NL-13-122

SUBJECT: Reply to Request for Additional Information Regarding
the License Renewal Application
Indian Point Nuclear Generating Unit Nos. 2 & 3
Docket Nos. 50-247 and 50-286
License Nos. DPR-26 and DPR-64

REQUEST FOR ADDITIONAL INFORMATION, SET 2013-04
RELATED TO INDIAN POINT NUCLEAR GENERATING UNIT NOS. 2 AND 3
LICENSE RENEWAL APPLICATION

REACTOR VESSEL INTERNALS PROGRAM AND INSPECTION PLAN

Figure 1 Lower Radial Support System Engagement

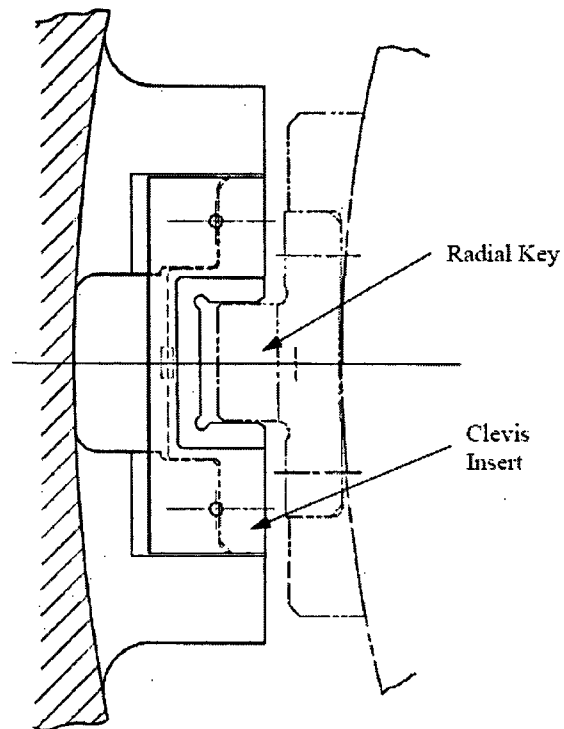
Appendix A to MRP-227-A indicates that failures of Alloy X-750 clevis insert bolts were reported by one Westinghouse-designed plant in 2010. A recent metallurgical analysis of bolts removed from this plant confirmed that the bolts cracked due to primary water stress corrosion cracking (PWSCC). Appendix A to MRP-227-A indicates that most of the failures of Alloy X-750 material have occurred in material with heat treatment condition AH1, while Alloy X-750 given the high temperature heat treatment (HTH) has proved more resistant to PWSCC.

The only aging mechanism requiring management by MRP-227-A for the clevis insert bolts is wear. The clevis insert bolts are categorized as an "Existing Programs" component under MRP-227-A, with the ASME Code, Section XI Inservice Inspection program credited for managing aging due to wear only. The ASME Code, Section XI specifies a VT-3 visual inspection for the clevis insert bolts which may not be adequate to detect cracking before it results in bolt failure.

The staff requests that Entergy modify the MRP-227-A inspection requirement for the clevis insert bolts as necessary to manage the effects of PWSCC for the IP2 and IP3 bolts. If the inspection requirement is not modified, the staff requests that Entergy provide a technical justification for the adequacy of the existing inspection requirement to manage PWSCC.

Complete disengagement of one of the clevis inserts is highly unlikely based on the available gaps with surrounding components (see Figure 1). Even if it were postulated that one of the clevis inserts becomes non-functional, the other lower radial supports are capable of resisting all of the internal and external asymmetric loads. Wear or some degradation of a key might occur, but the key would still be expected to maintain functionality. Taken as a whole, the core barrel and LRSS system are expected to maintain their design function with degraded clevis insert bolts. Based on the evaluations performed to date, there are no safety or operability concerns with clevis insert bolt failure.
